1. Type of Well ☐ Oil Well					8. Well Name and No. JAMES RANCH UNIT 070		
2. Name of Operator Contact: TRACIE J CHERRY BOPCO LP E-Mail: tracie_cherry@xtoenergy.com					9. API Well No. 30-015-28012		
3a. Address P O BOX 2760 MIDLAND, TX 79702	O BOX 2760 Ph: 432-683-2277					10. Field and Pool or Exploratory Area LIVINGSTON RDG;ATOKA NE

WBD - Vertical - Proposed Well Name: JAMES RANCH UNIT #070 Field: Livingston Ridge Northeast (atoka)

Permanent Abandonment of Federal Wells Conditions of Approval

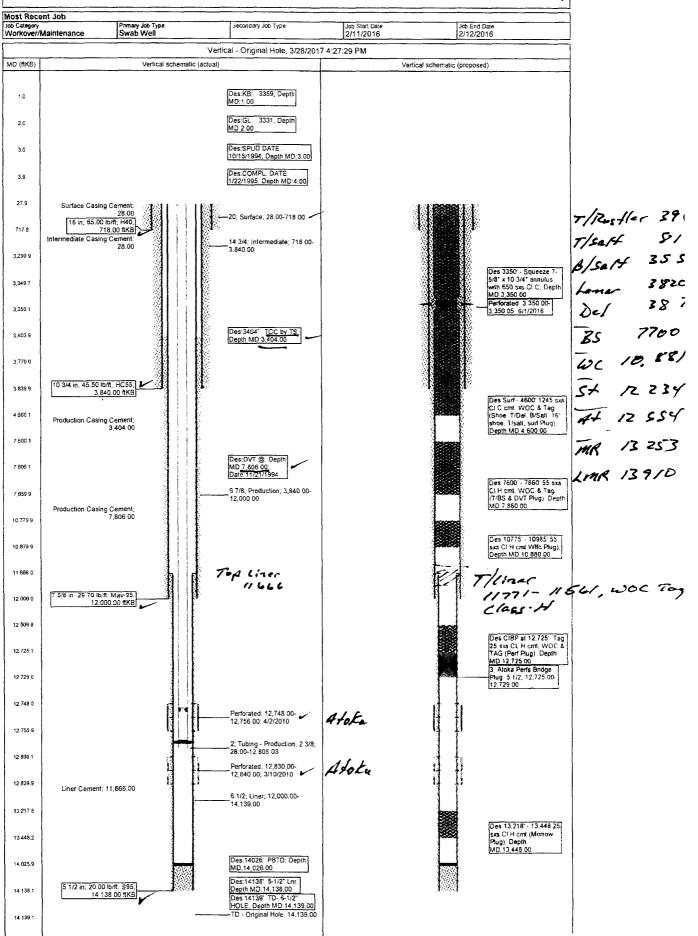
7. PU 5-1/2" CIBP on WL and set at 12,725'. RIH with workstring and tag CIBP. Spot 25 sks API_______ Standard Class H cement on top of CIBP. (Perf plug) /2.725 - /2,/84 Cover Top Strawn. Add phag From //77/-//56/ Covers Lines Top. Loose Top Class H 8. PUH to 10,985'. Spot 55 sxs API Standard Class H cement from 10,985' - 10,775'. (Wolfcamp plug)
